ALLEGHENY COUNTY SANITARY AUTHORITY

CONTRACT NO. 1729 G, E, H, P

EAST HEADWORKS

ADDENDUM NO. 8

TYPICAL BASE AT UHPC PANEL 2
SCALE: 1 1/2" = 1'-0" 530-A-26

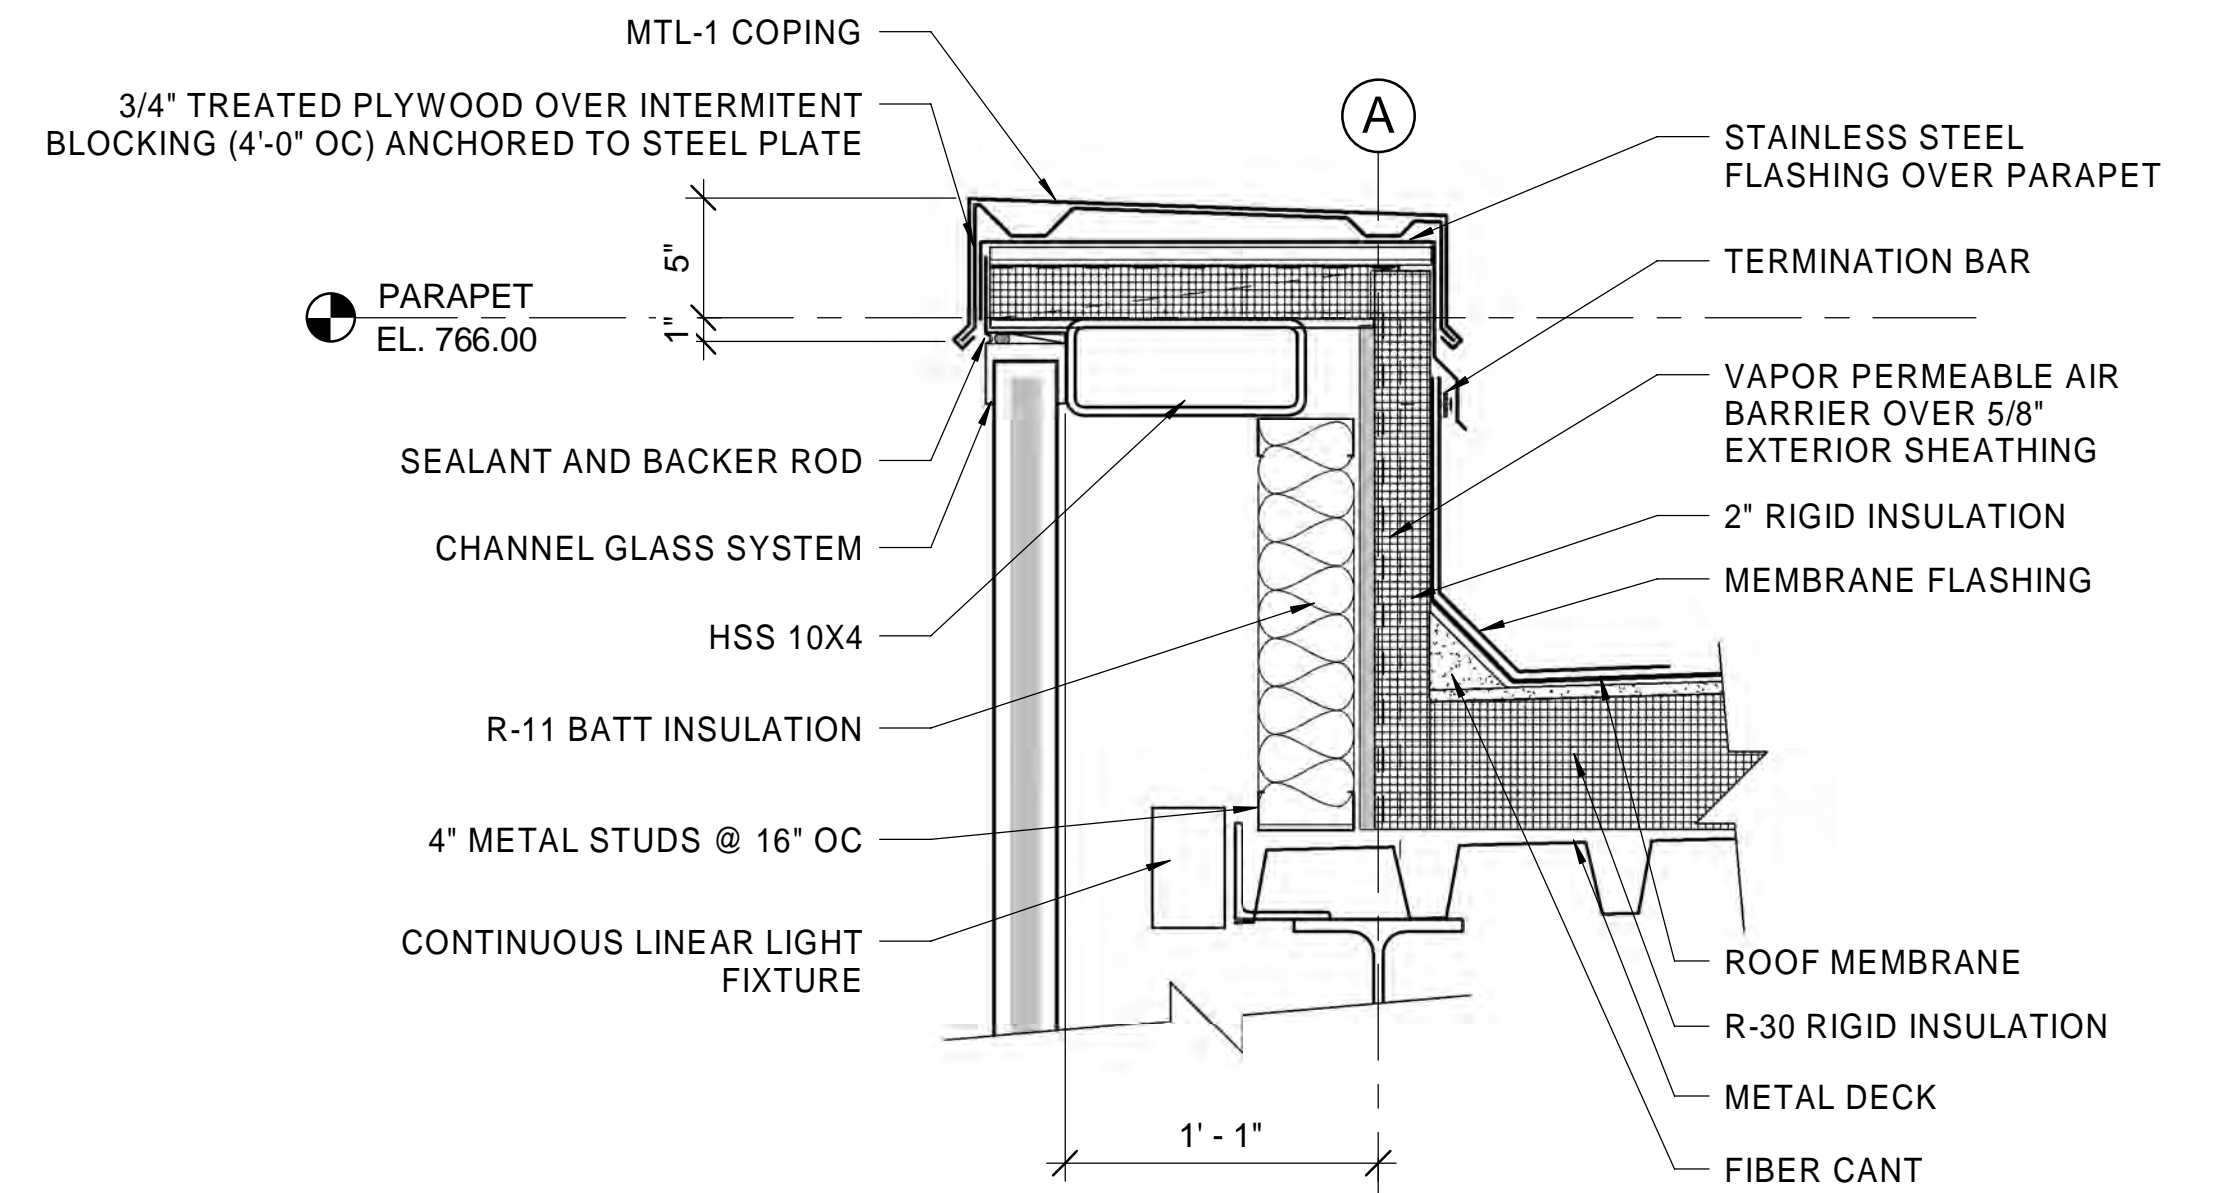
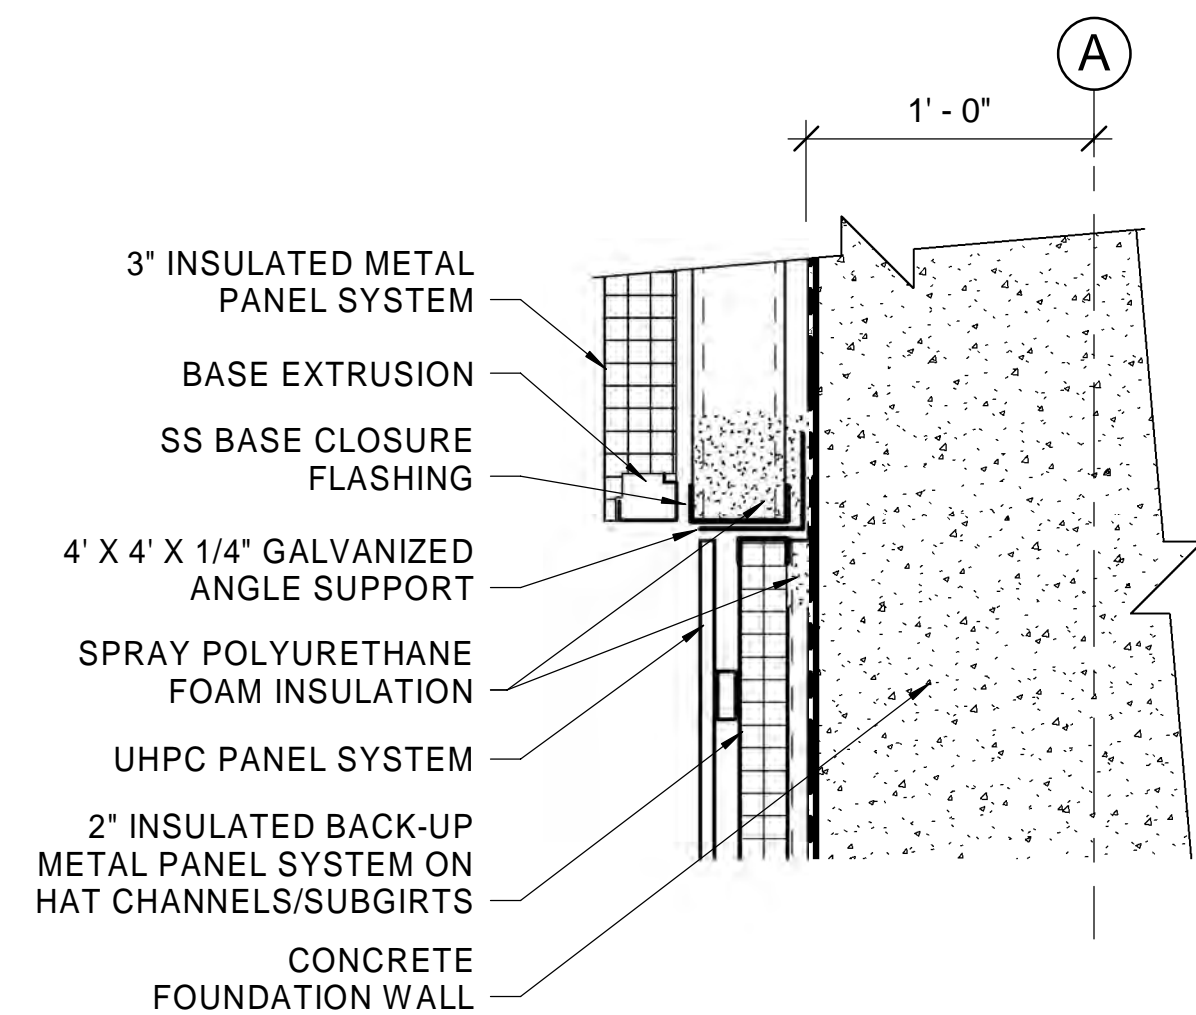
180. **QUESTION:** Reference wall section 1 on sheet 530-A-26: This section shows the UHPC panels over "rigid insulation". Other similar wall sections, such as 3 on sheet 530-A-26, identify the insulation as "foam insulation". These sections and other similar wall sections refer to details 2 and 7 on sheet 530-A-46. These two details, however, show the UHPC panel system installed over the 2" insulated back-up metal panel system on hat channels. Please clarify if the UHPC panels are to be installed over rigid foam insulation or the insulated back-up metal panel system. Also, we do not believe details 2 and 7 on sheet 530-A-46 show all of the necessary sub-framing components for both the back-up metal panel and the UHPC panel systems.

RESPONSE: The UHPC panel system is installed over 2" insulated back-up metal panel system on hat channels per Details 2 and 7 on 530-A-46. The UHPC panels and back up panel manufacturers are responsible for providing the required panel supports, at spacing as required by the manufacturer. For the UHPC panel system, provide concealed attachment system per Specification Section 07 42 47, Part 2.3. For the 2" insulated backup panels, provide subgirts (hat channels) and panel attachment clips per Specification Section 07 42 17.10, Part 2.4.
